7ELEVEN AT WALLBROOK (LOT 11)

SITE DEVELOPMENT PLAN

US-401 Business / S. Main Street ~ Wake Forest Township ~ Town of Rolesville ~ Wake County ~ North Carolina

COVER - OVERALL SITE PLAN
7ELEVEN AT WALLBROOK (LOT 11)
Town of Rolesville Project No. SDP 23-
US 401 Business / S. Main Street & Virginia Water Drive
Wake Forest Township, Town of Rolesville, Wake County, North Carolina

C0.1

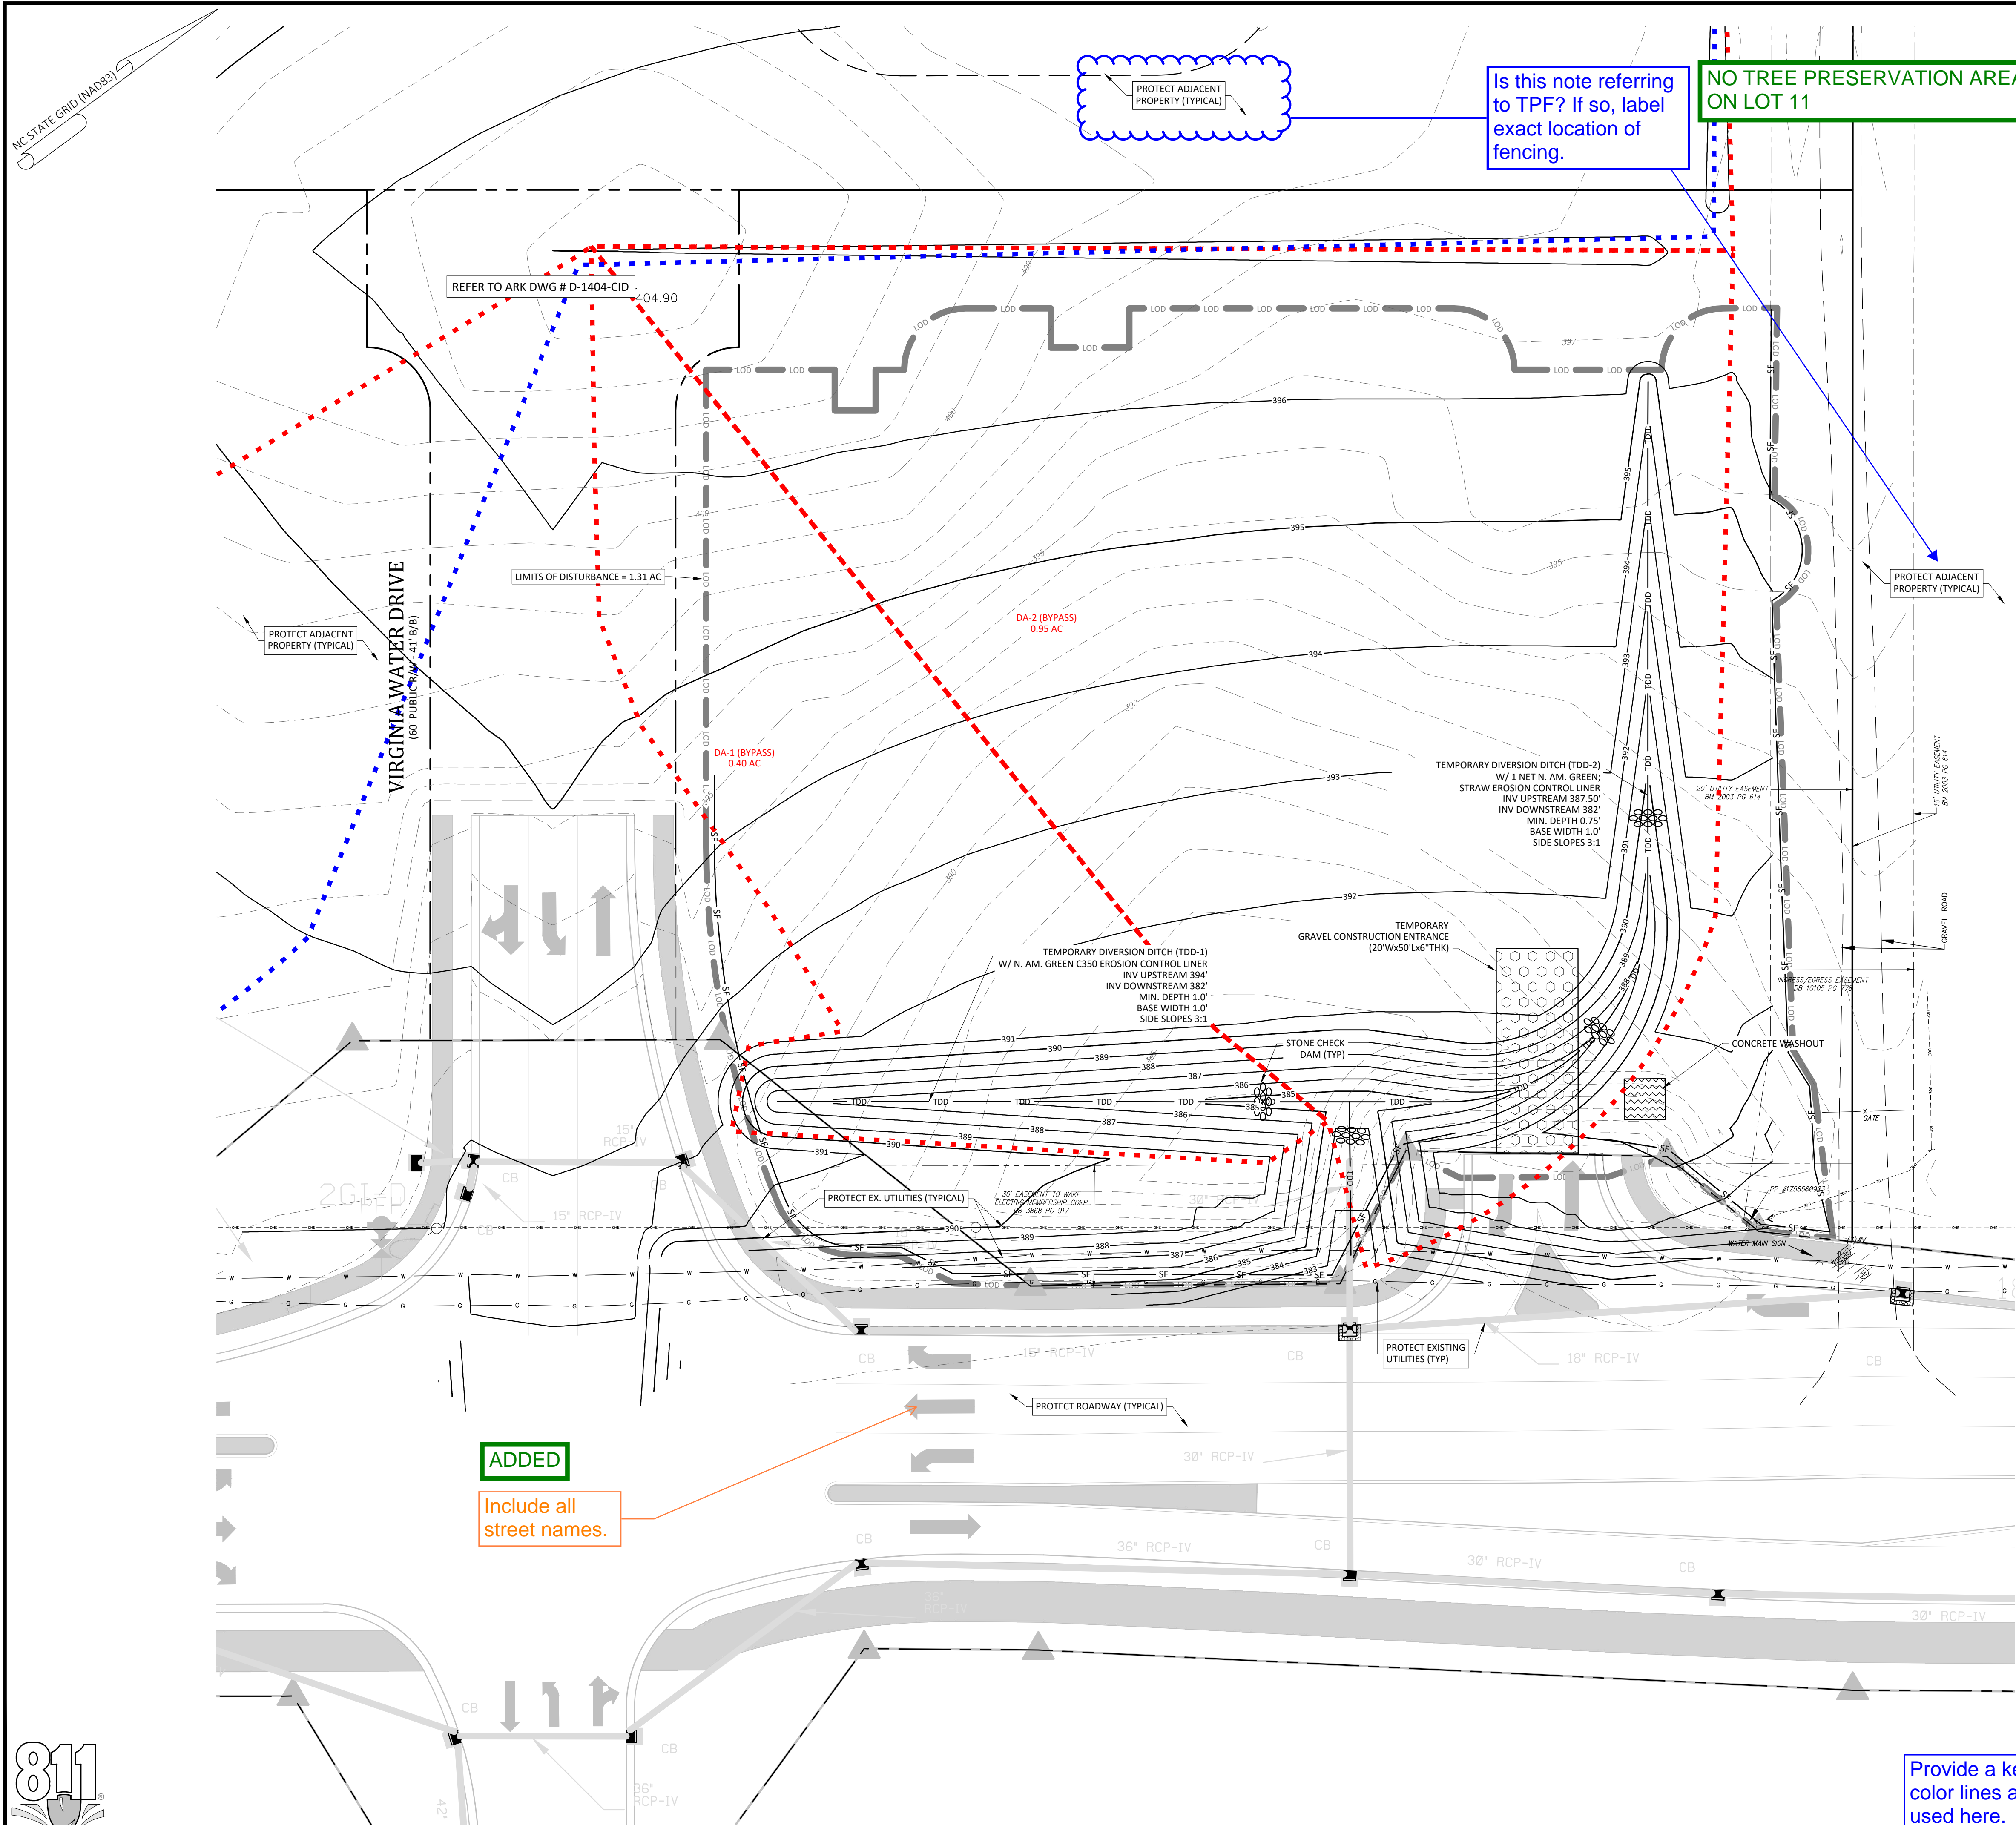
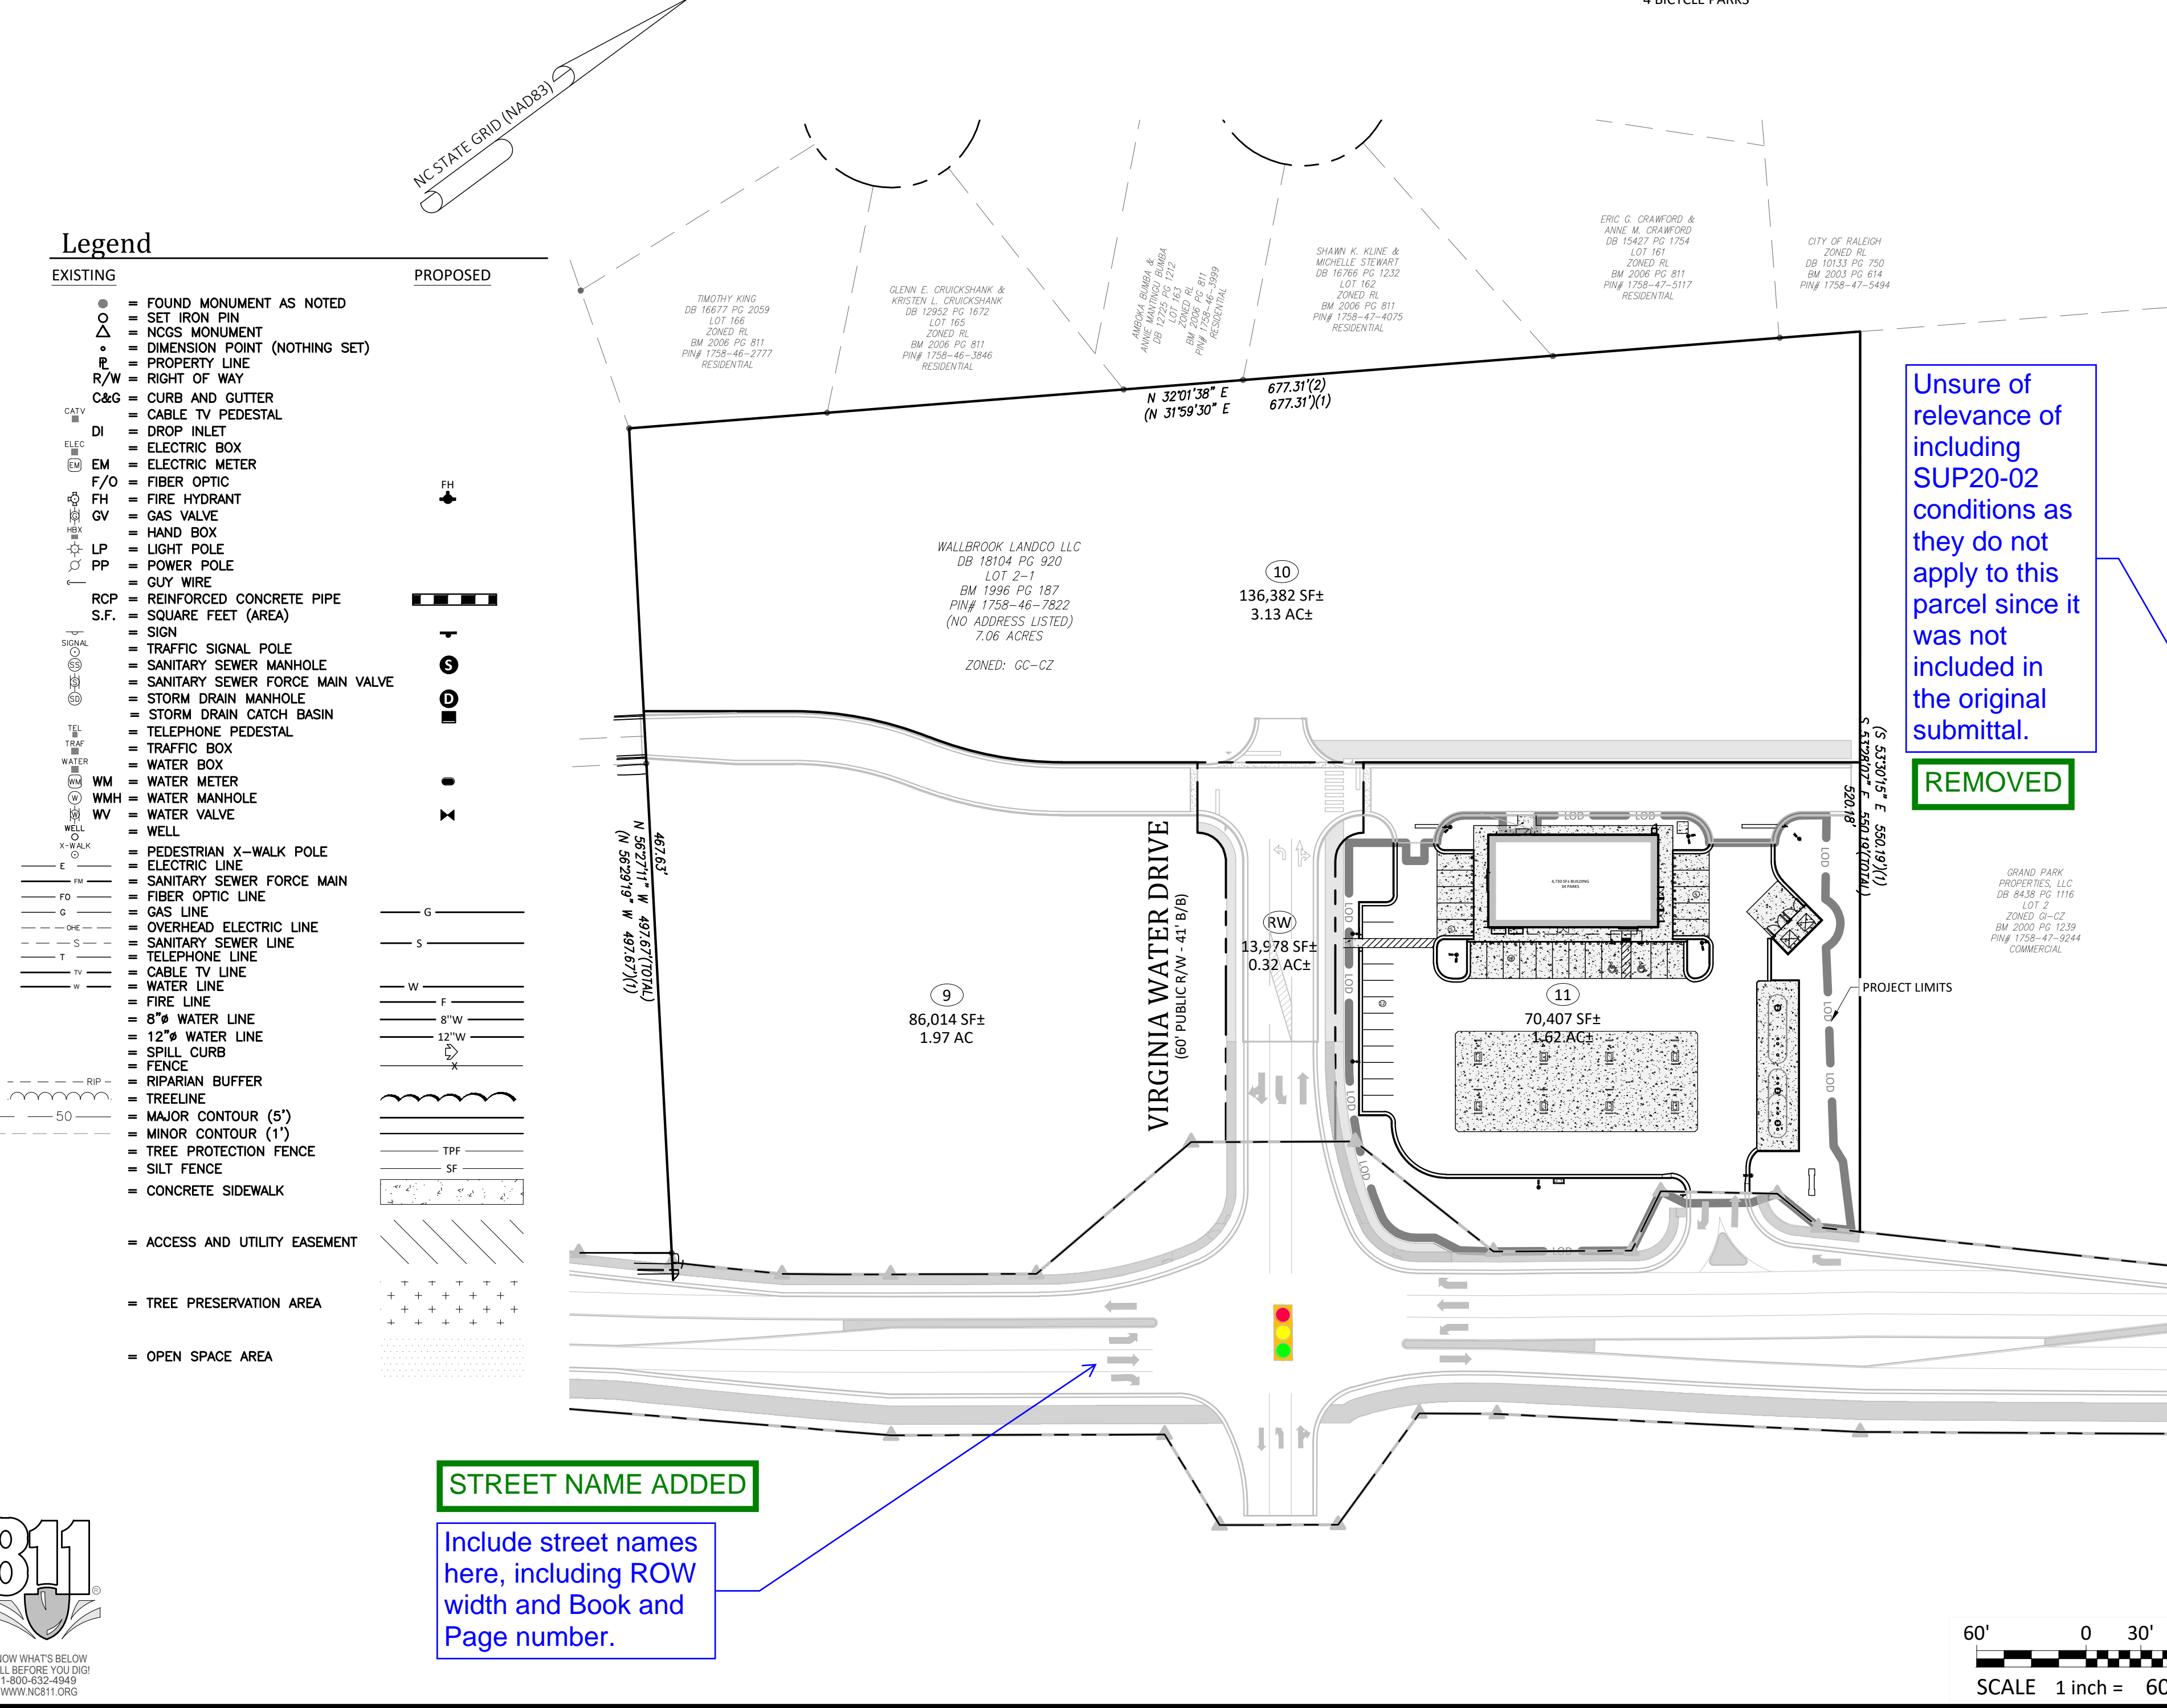
ADDED Add site plan number SDP-23-04 to the cover sheet.

Add setbacks and open space required and demonstrate compliance

Update FIRM map to include the most recent dates/numbers.

Unsure of relevance of including SUP20-02 conditions as they do not apply to this parcel since it was not included in the original submittal.

Include date of drawing.

Include street names here, including ROW width and Book and Page number.

Please provide a existing conditions sheet including tree preservation area consistent with PR21-04 REV.

Please provide a lighting plan sheet compliant with LDO Section 6.6.F and 6.6.M

NOTE ADDED TO REFER TO PR 21-04 REV FOR OPEN SPACE REQUIREMENTS

UPDATED TO REFLECT CURRENT EFFECTIVE MAP REFERENCE.

REMOVED

REVISED

STREET NAME ADDED

EXISTING CONDITIONS SHOWN ON SHEET C1.0. NOT TREE PRESERVATION ON LOT 11. LIGHTING PLAN INCLUDED WITH THIS SUBMITTAL

EROSION CONTROL PLAN - PH. 1
7ELEVEN AT WALLBROOK (LOT 11)
Town of Rolesville Project No. SDP 23-
US 401 Business / S. Main Street & Virginia Water Drive
Wake Forest Township, Town of Rolesville, Wake County, North Carolina

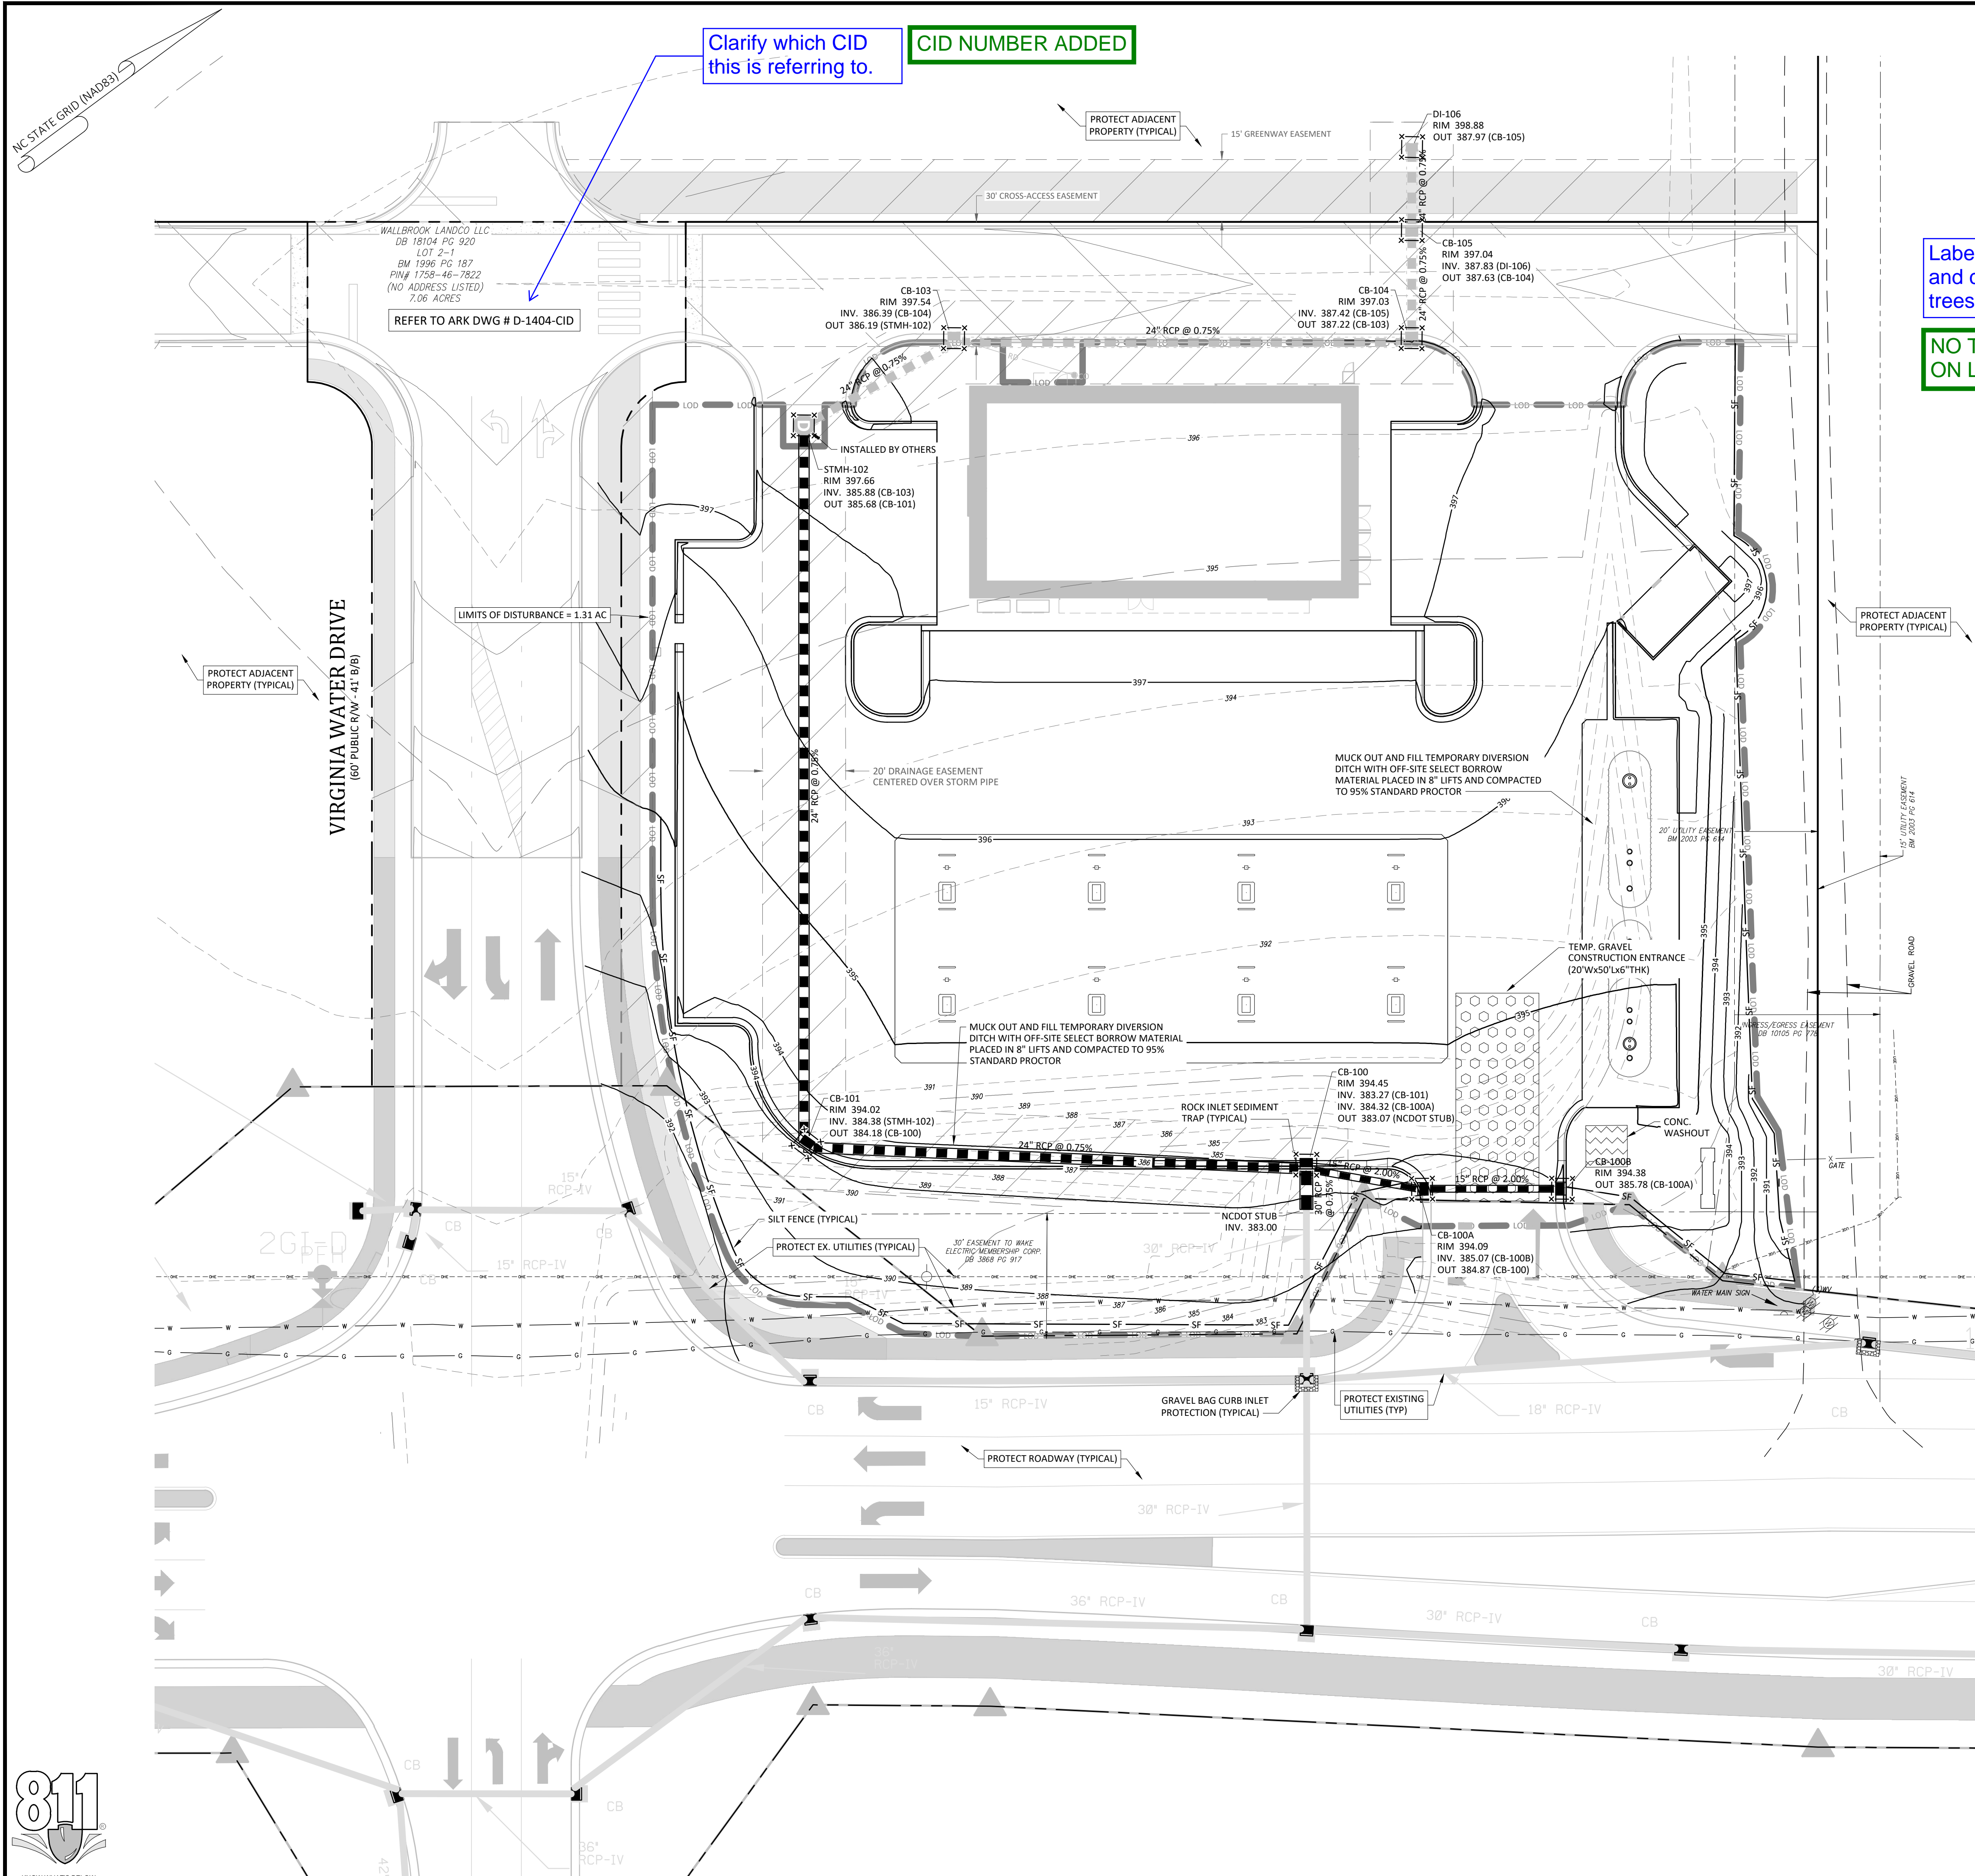
Provide a key/legend for the different color lines and symbols shown and used here.

DRAINAGE AREA LINES ADDED TO LEGEND ON SHEET C0.1
